Willow Rock Energy Storage Center (21-AFC-02)

DATA REQUEST RESPONSE SET 1

Response to California Energy Commission Staff Data Requests 1 through 112

BLM ALTERNATIVE SITE MAP

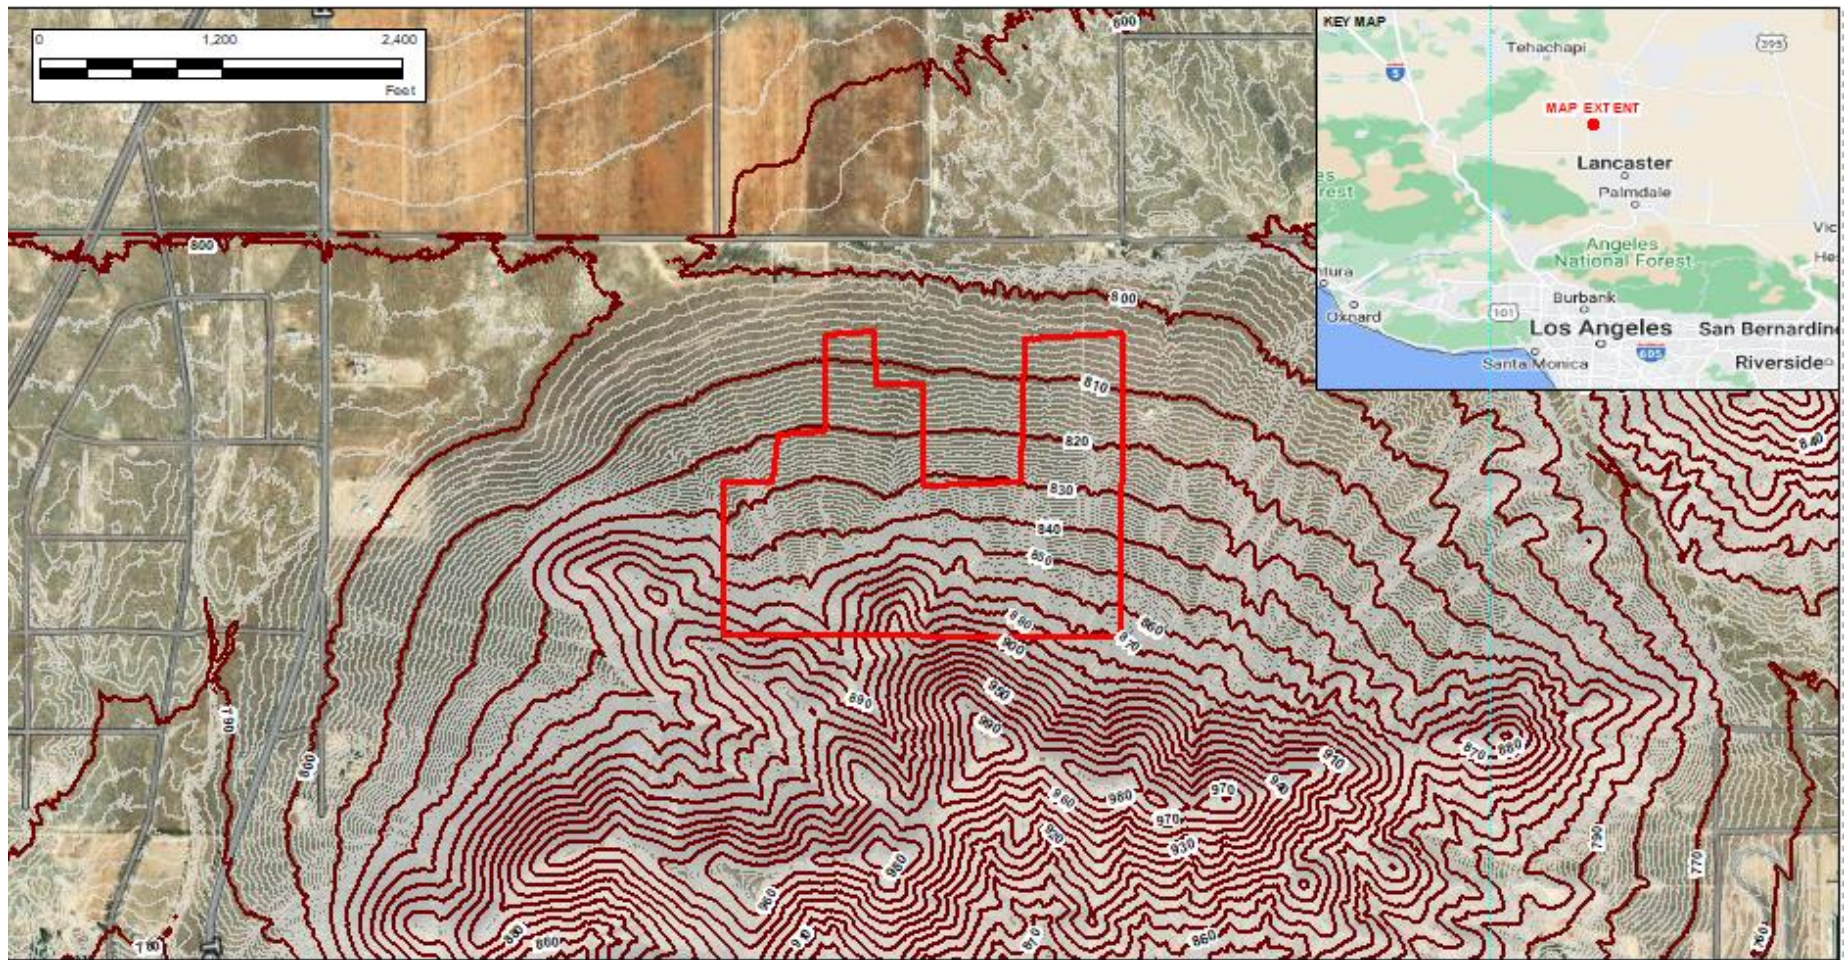
DR6: Please provide a copy of Hydrostor's preliminary geologic examination of the area and a large-scale map (i.e., zoomed in) of the BLM site. Please include similar maps of the Rosamond Hills and Little Buttes sites.

Response: Please see Applicant's Notice Pursuant to 20 CCR § 1716(f) Regarding Staff's Data Requests Set 1, submitted on August 15, 2022, which respectfully objects to this data request. A nonconfidential summary of the geotechnical examination is provided in Attachment DR6-1 Larger scale maps of the BLM, Rosamond Hills and Little Buttes sites are provided in Attachments DR6-2, DR6-3 and DR6-4.

FIGURE 5.7-2 LONG-TERM BASELINE SOUND PRESSURE LEVELS, ONE MINUTE INTERVALS

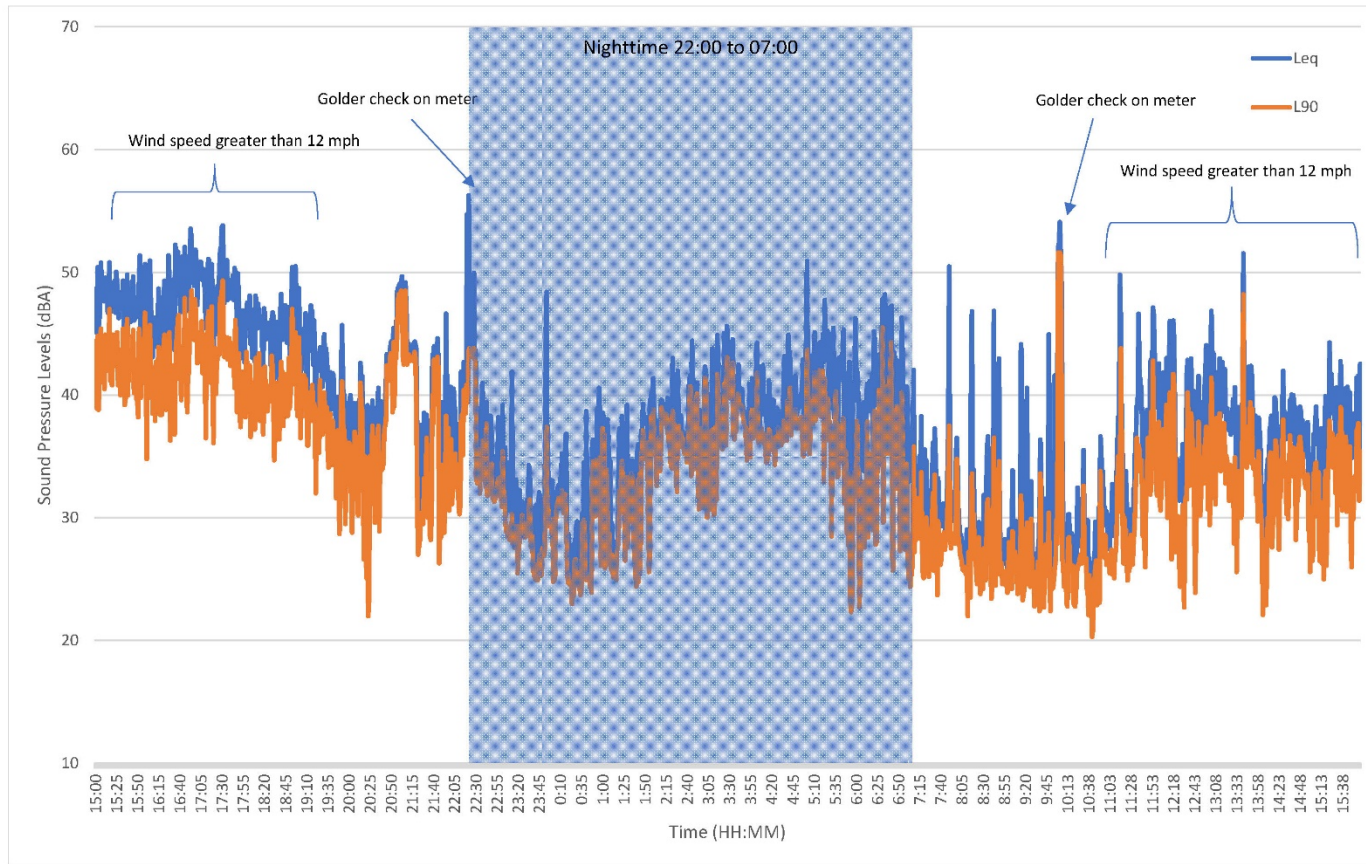
The Sound Pressure Level (SPL) versus time data presented in Table 5.7-5 of the AFC (Summary of Long-term Sound Pressure Levels) for existing long-term ambient noise near noise monitoring location Site 2 does not match the SPL versus time data in Figure 5.7-2 of the AFC (Long-Term Baseline Sound Pressure Levels, One Minute Intervals), which staff understands is a graphical representation of the same data as in the table. For example, in Table 5.7-5, at 0:00 hours on Friday July 9, 2021, the SPL L_{eq} is 32.8 dBA, while in Figure 5.7-2 the SPL L_{eq} at 0:00 hours is above 40 dBA. Another example is that all of the data points for L_{90} in the table that are below 30 dBA, does not correspond to L_{90} data below 30 dBA during the same time taken. Also, the graph shows that the observed noise levels during the night are higher than during the day, which is not typical, as the nighttime noise levels are usually lower than the daytime ones.

DR78: Please provide an explanation for the discrepancy between the data presented in Table 5.7-5 and Figure 5.7-2.

Response: Data presented in AFC Table 5.7-5 is accurate. AFC Figure 5.7-2 presented erroneous data, see revised AFC Table 5.7-4 is provided as Attachment DR78-1 and AFC Figure 5.7-2 as Attachment DR78-2. The noise level average for the Long-Term Monitoring location was 44 dBA during the daytime and 40 dBA at night.
